Technical Comment

File Reference: APP-20181676

Subject: *Request for Technical Comment*

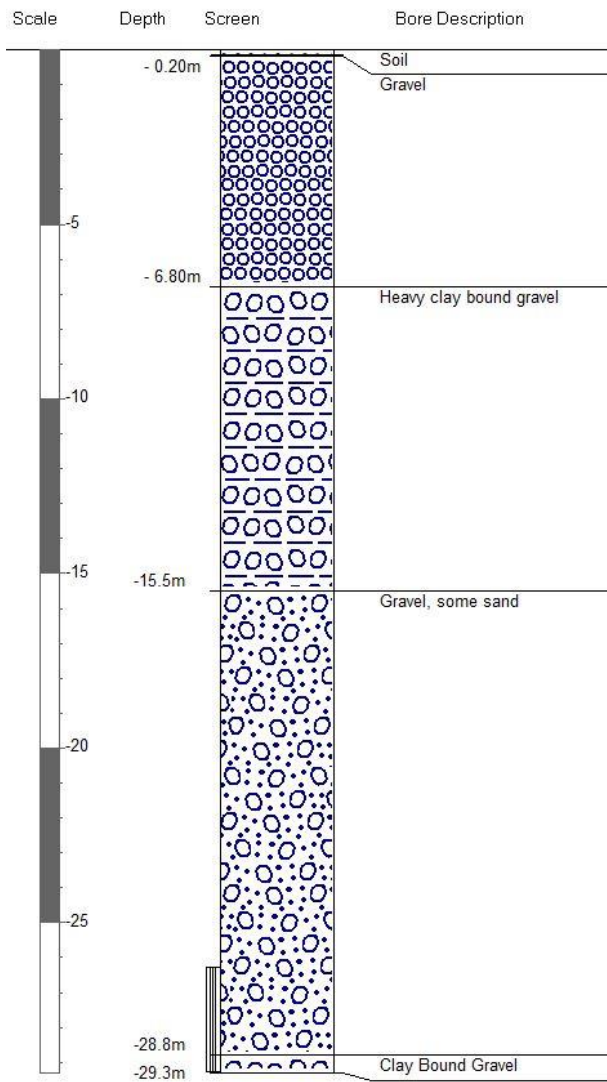
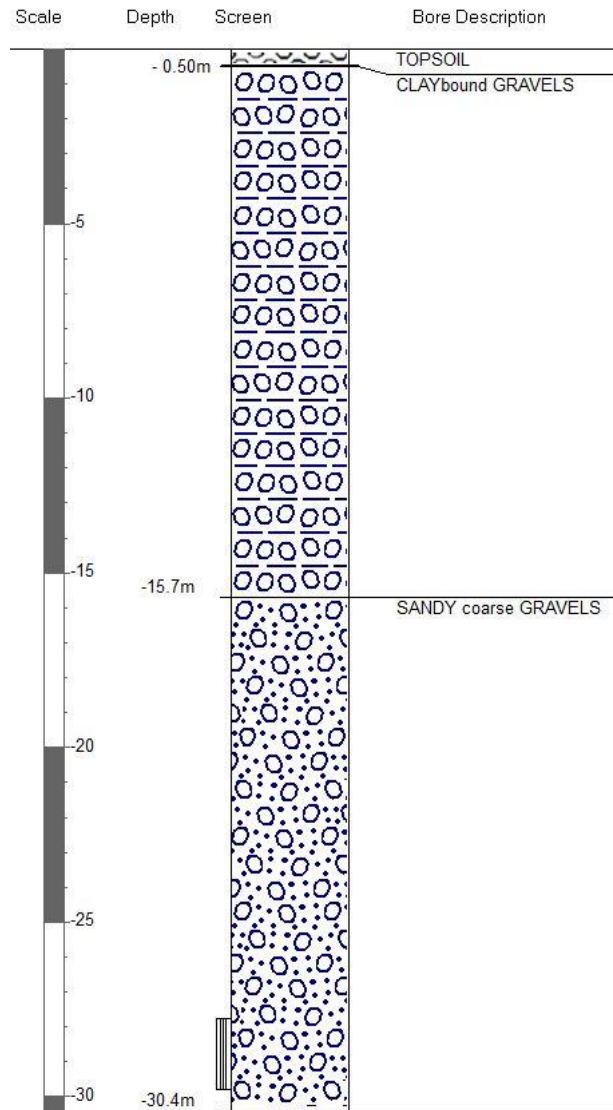
The existing take under AUTH-204993 from E44/0370 on the applicant's property is accounted in ES allocation records to be from Castlerock Groundwater Management Zone (GMZ), however, the depth, bore log, initial water level measurement (-4.68m in April, 2016) and location within the estimated extent of Lumsden aquifer all point to it being sourced from the Lumsden aquifer. The AEE for AUTH-204933 appears to make an assumption of an unconfined take without any supporting evidence, and this was not questioned in considering the application – perhaps due to the modest size of the take (43,800m³/year). It is worth considering, however, that a recommendation will be forthcoming to add this take to the current Lumsden aquifer allocation. Borelogs of E44/0623, used for irrigation under AUTH-20171076 and sourced in Lumsden aquifer, and E44/0370 are shown in Figure 1 below.

Borelog for well E44/0623

Borelog for well E44/0370
